SERVICE BULLETIN

ATI S.B. No. 03-01, Rev. A

Auxiliary Dry Air Pump Kit No. AP8-100 STC SA4626NM **Replacement Parts**

Auxiliary Dry Air Pump Kit No. AP8-100 STC SA4626NM Wiring Modification

NEW WIRING CONFIGURATION

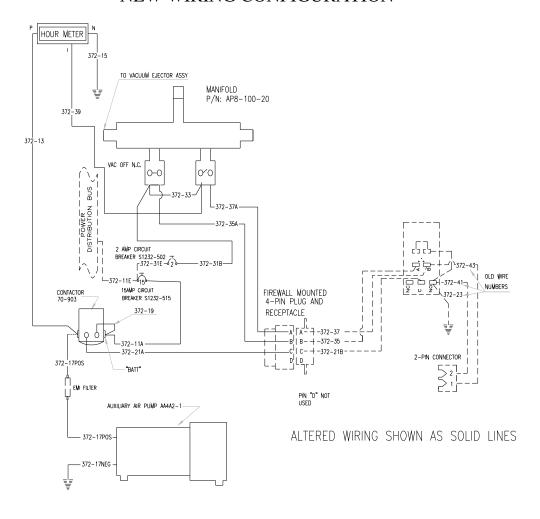
- 1) Replace the old auxiliary vacuum pump, manifold assembly, and hour-meter in accordance with (IAW) "Installation Instructions", Document number AP8-1M, Rev: D, dated May 22, 2003, or latest approved revision. Operators desiring to replace only the above listed items may modify the existing aircraft wiring installation IAW pages 2 and 3 of this service bulletin.
- 2) Replace the old "Instructions For Continued Airworthiness" with instructions updated by Rev: C, dated September 9, 2002 or later approved revision.
- 3) Replace the old FAA Approved Airplane Flight Manual Supplement with the AFMS Rev: A, dated March 11, 2003 or later approved revision.
